HISTORIC AND DESIGN REVIEW COMMISSION

HDRC CASE NO: 2014-376
ADDRESS: 700 W COMMERCE ST
LEGAL DESCRIPTION: NCB 299 BLK 24 LOT 1 THRU 14
ZONING: D H HS
CITY COUNCIL DIST.: 5
DISTRICT: Cattleman Square Historic District
LANDMARK: Toudouze Market & Buildings 2, 3, and #4
APPLICANT: STG Design
OWNER: Michael Wibracht/210 Developers
TYPE OF WORK: New construction of mixed-use development
REQUEST:

The applicant is requesting conceptual approval to:

W. COMMERCE ST. ELEVATION

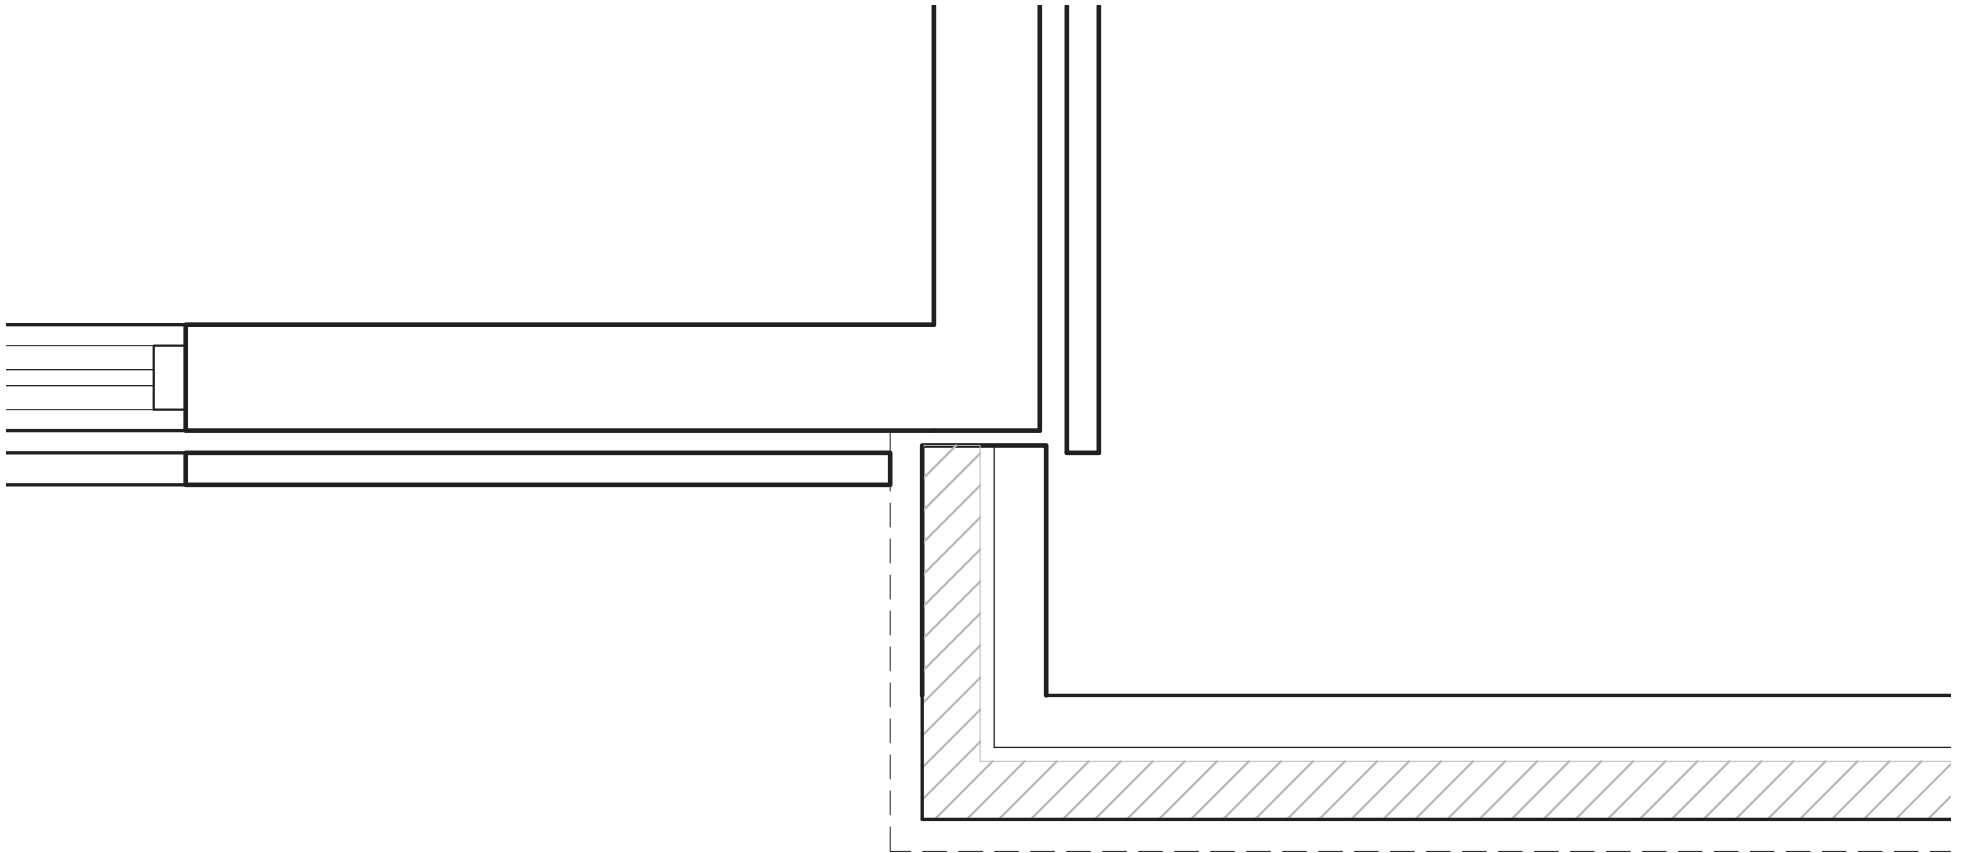
- o) According to the Guidelines for Exterior Maintenance and Alterations 10.B.ii., commercial storefronts should be restored based on photographic evidence. The proposal reintroduces a canopy to the storefront. Additionally, at the suggestion of the HDRC, the applicant has indicated that the columns at the ground level will be restored using matching brick. The ground level storefront has been modified, so the current proposal will be an improvement consistent with the Guidelines. Further restoration of the historic storefront based on photographic evidence could

serve to mitigate the partial demolition of the structure.

REVEAL DETAIL

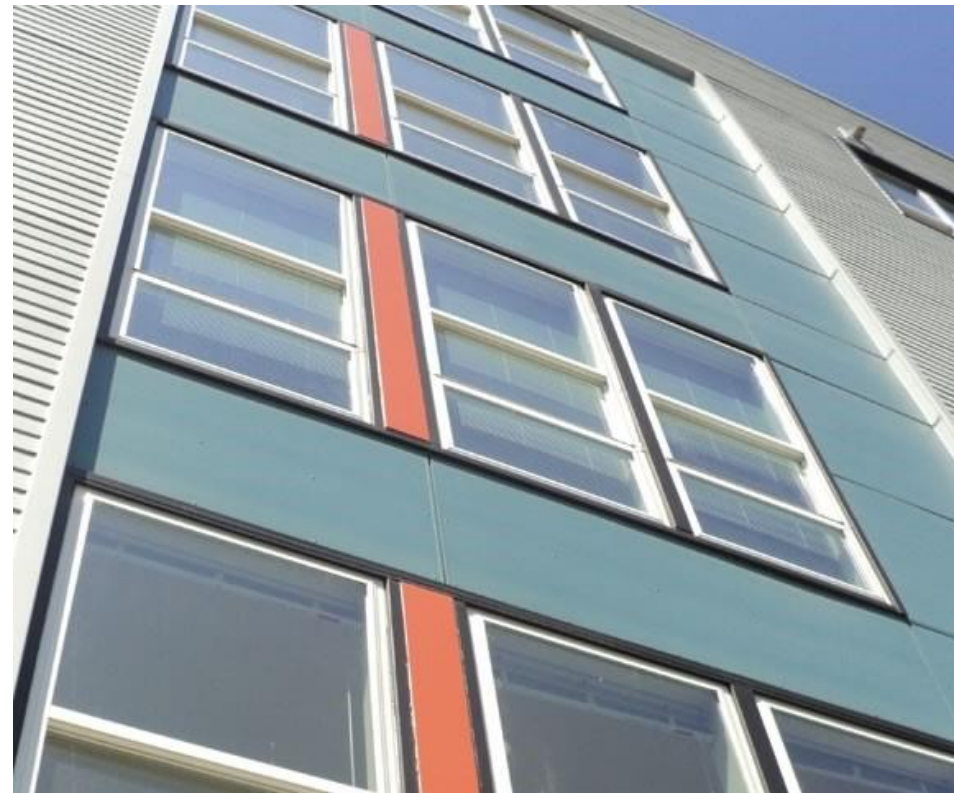
- i) According to the Guidelines for New Construction 2.B.ii., when the height of new construction exceeds the adjacent historic building, a variation in building massing should be implemented to provide clear a visual transition between the old and the new. The applicant has provided a detail that maintains a reveal between the Maureaux building and the proposed new construction.
